Australian Resources Development Pty Ltd

Submission regarding GenCost 2024-25 Consultation draft

11 February 2025

Chart 1: GenCost25 Draft and ISP24 projected generation technology mixes

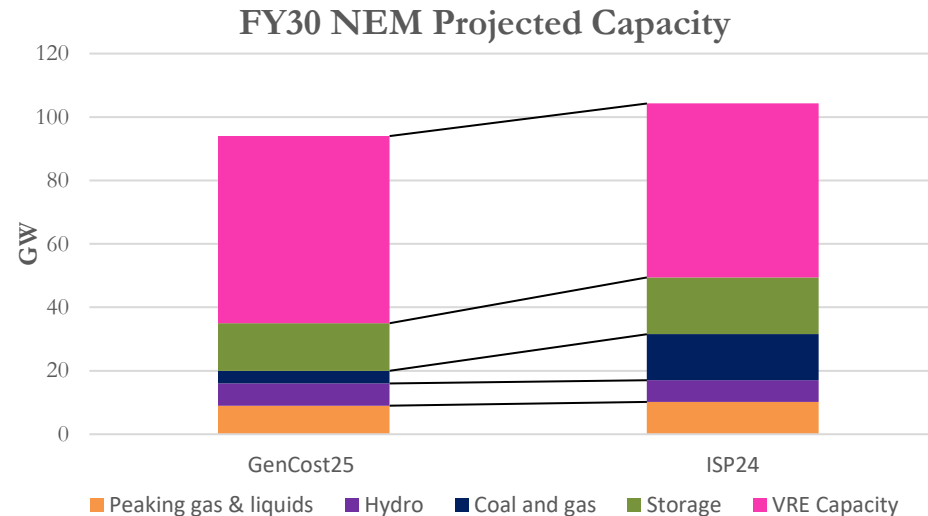
Chart 1 sets out the projected generation technology mixes from GenCost25 Draft (Figure 6.7, page 69¹) and ISP24, excluding Rooftop PV. The GenCost25 Draft VRE capacity is approximately 59GW for a 90% VRE Share of generation. The ISP24 VRE capacity is approximately 55GW for a 65% VRE Share. Both technology mixes are projected to deliver the load reliably in FY30, excluding Rooftop PV. The GenCost25 Draft load is “lower” by an unknown amount² (page 62).

GenCost25 Draft projects significantly less dispatchable capacity (~35GW) in FY30 than the ISP24 (~49GW) to support a much higher VRE Share.

GenCost25 Draft requires a projected DRM of 95% to provide a reliable system in FY30 with a 90% VRE Share. In marked contrast, the ISP24 requires a projected DRM of 134% with a 65% VRE Share to achieve the same outcome.

Chart 2: VRE penetration and real Australian consumer electricity prices

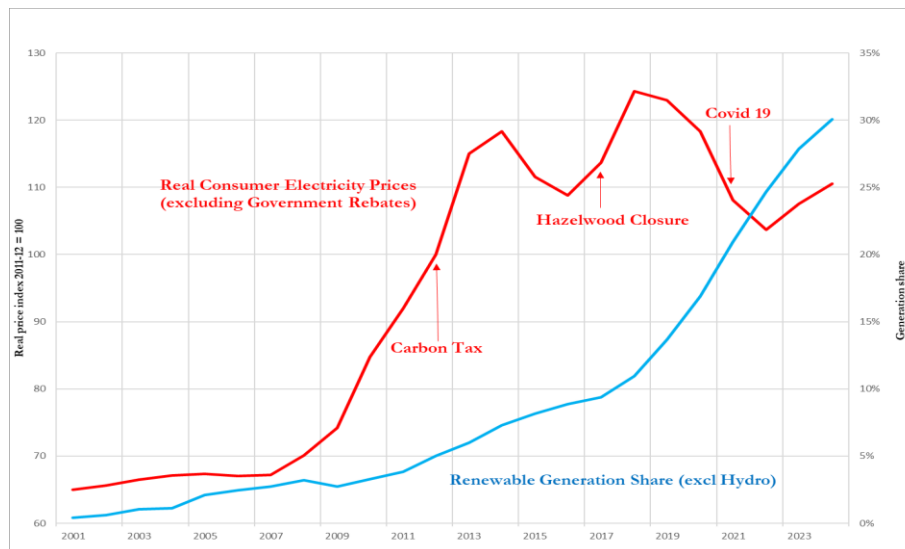
Chart 2 shows that the share of total electricity generation attributable to VRE technologies (excluding hydro, including Rooftop PV) has risen dramatically since 2009. This increase in the VRE Share has coincided with a significant increase in real, retail consumer electricity prices.

The increase in VRE Share has largely been achieved by reducing coal-fired generation's share of total generation from approximately 85% in FY09 to approximately 56% in FY24. The major drivers of this reduction in the coal-fired generation share are the dispatch preference given to renewables and the Pre-FY24 Subsidies (see Slide 22).

Chart 3: NEM price-setting dynamics by fuel

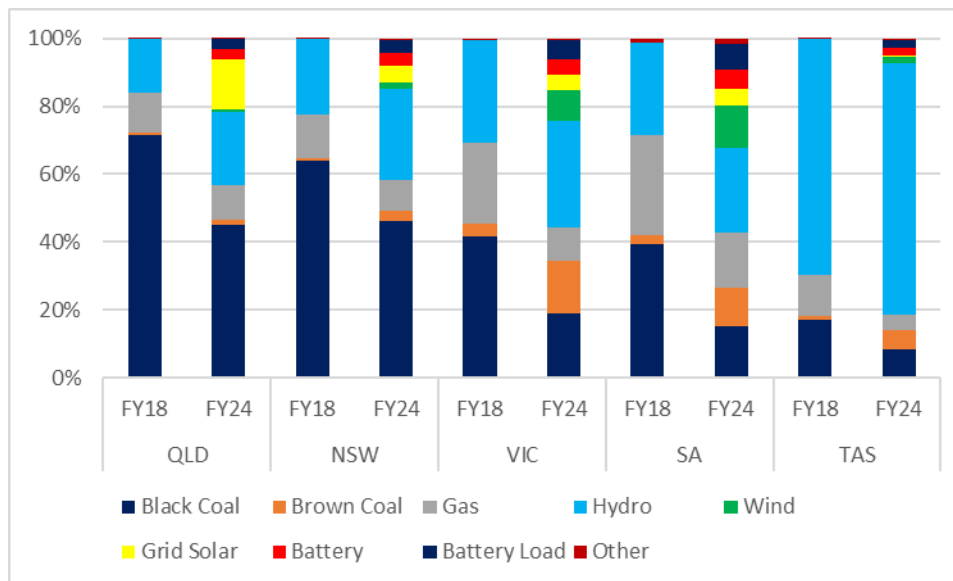
Chart 3 sets out the NEM price-setting dynamics by fuel derived from various issues of AEMO's Quarterly Energy Dynamics (**QED**) for FY18 through FY24.

The Chart shows that in FY18, NEM prices were set predominantly by coal in all regions except Tasmania. The proportion of the time coal set the prices ranged from 73% in QLD, 65% in NSW, 46% in VIC and 42% in SA. QED notes that coal generators in another region may set the price in some periods. The next dominant price setting fuel was hydro, with gas setting the price in SA 30% of the time, VIC 24%, NSW 13% and QLD 12%.

Chart A2: NEM monthly wind generation – January 2010 to September 2023

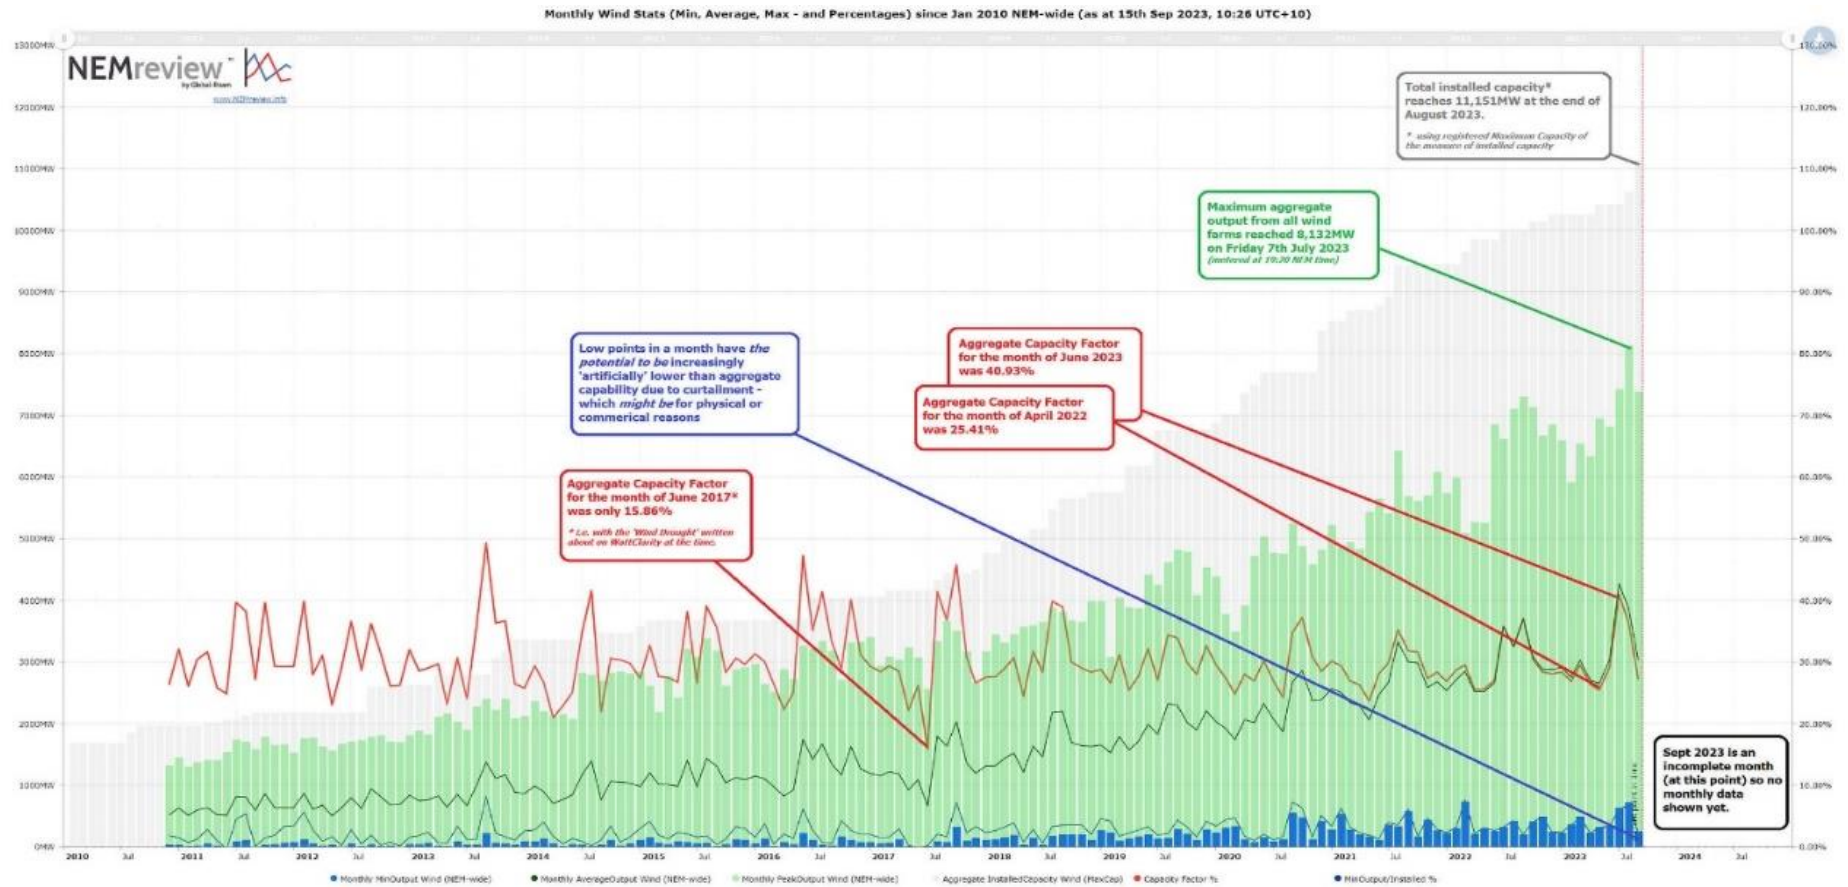
Finally, Chart A2, published in NEMreview by Global Roam demonstrates that the minimum monthly aggregate wind CF in the NEM was effectively zero over several months in the last decade.
